Subject ▶ Change on construction of turn-base

For Models ▶ LS1013, LS1212

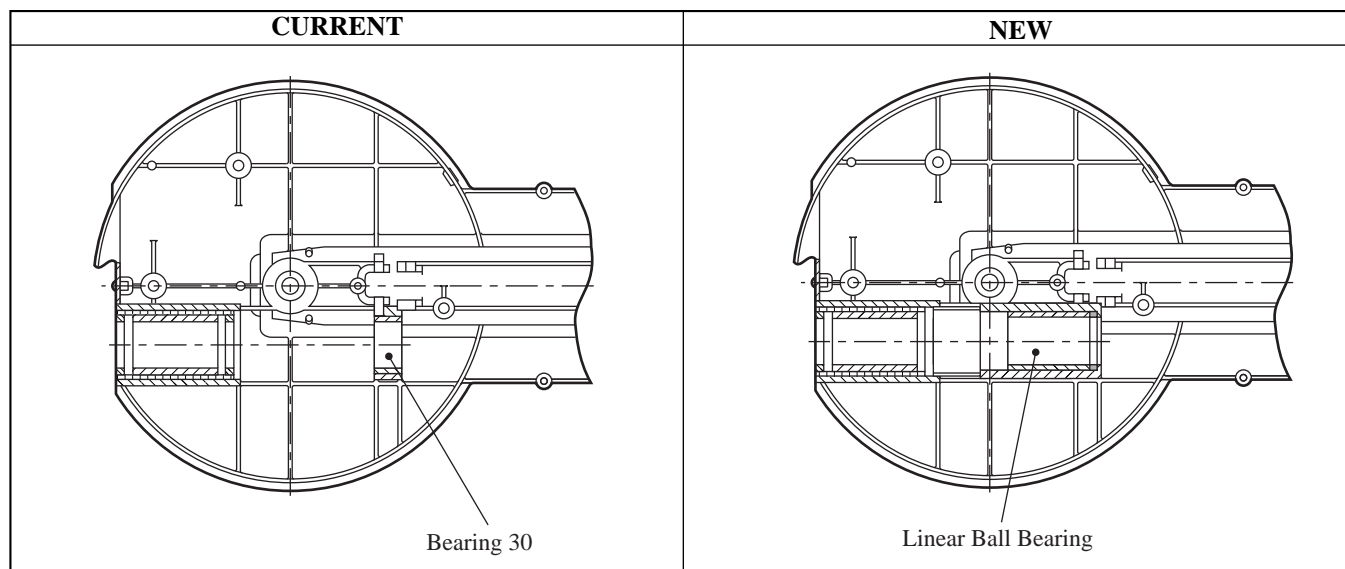
Description ▶ Bearing 30(PT219002-7), built in the turn-base for sliding sawhead, has been replaced with linear ball bearing 3050 (PT211439-4) to secure a smoother slide of sawhead.
